Lake Crabtree Park Improvements Bid Addendum #2

Date: 08/28/2026
Wake County RFB #: 26-078
WR Project #: 22-0024-007

Notice to All Bidders:

MAINTENANCE
BUILDING -
MECHANICAL PLAN -
BASE BID

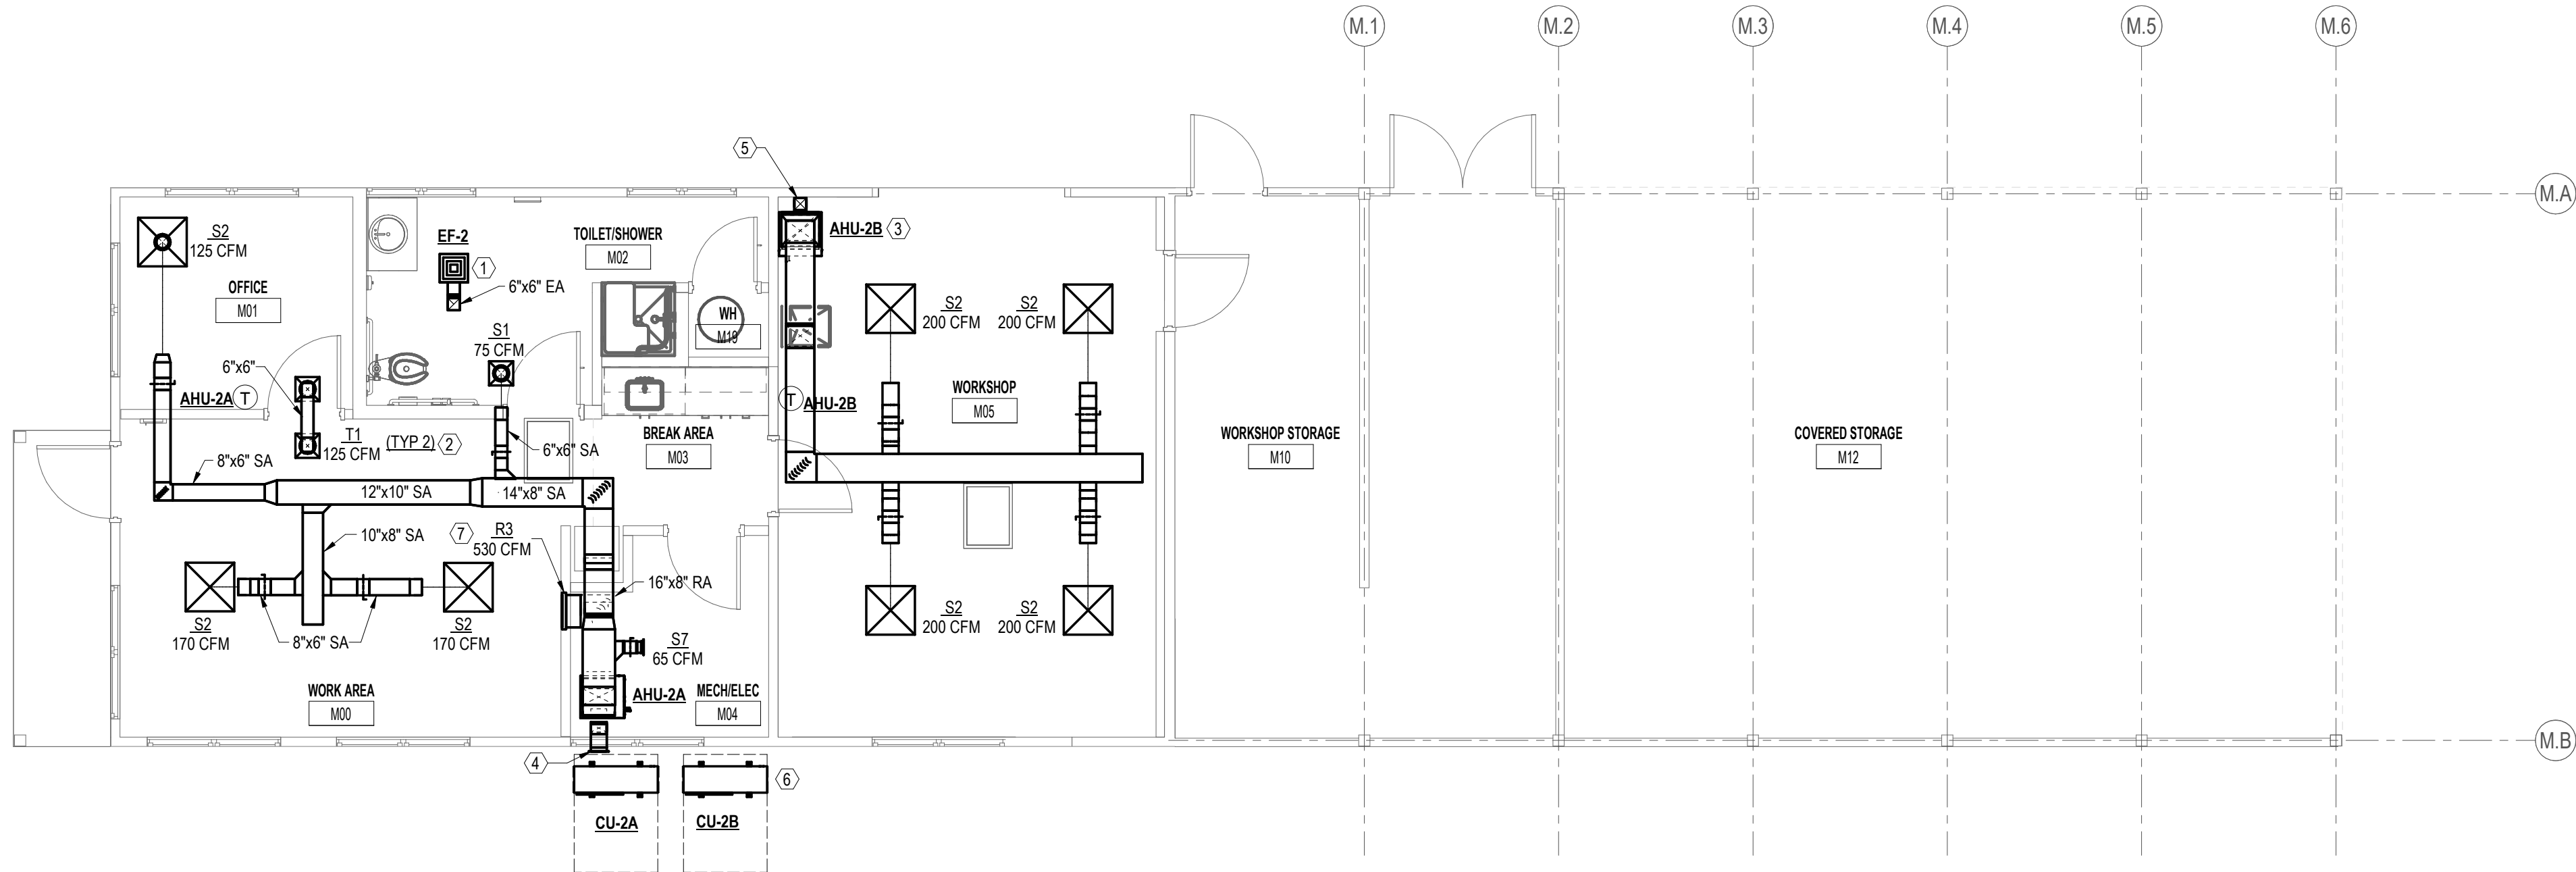
11. M3.10 - MAINTENANCE BUILDING - MECHANICAL PLAN - BASE BID
 - a. KEYNOTE 6 UPDATED
12. M4.10 - EDUCATION CENTER - LVL 0 MECHANICAL PLAN
 - a. KEYNOTE 4 UPDATED
13. E2.11 - ADMIN BUILDING - ELECTRICAL POWER PLAN
 - a. ADDED KEYNOTE 13 TO DESCRIBE FAULT CURRENT INSTRUCTIONS
14. E3.11 - MAINT. BUILDING ELECTRICAL POWER PLAN BASE BID
 - a. ADDED KEYNOTE 11 TO DESCRIBE FAULT CURRENT INSTRUCTIONS
15. E3.12 - MAIN. BUILDING - ELECTRICAL LIGHTING PLAN BASE BID
 - a. ADDED AND RELOCATED EMERGENCY LIGHT FIXTURES
 - b. ADDED EXIT SIGN
16. E4.10 - EDUCATION CENTER - LVL 0 ELECTRICAL POWER PLAN
 - a. ADDED KEYNOTE 15 TO DESCRIBE FAULT CURRENT INSTRUCTIONS
17. E4.11 - EDUCATION CENTER - LVL 1 ELECTRICAL POWER PLAN
 - a. ADDED REFERENCE TO FIRE ALARM ANNUNCIATOR PANEL
18. E4.13 - EDUCATION CENTER - LVL 1 ELECTRICAL LIGHTING PLAN
 - a. ADDED AND RELOCATED EMERGENCY LIGHT FIXTURES
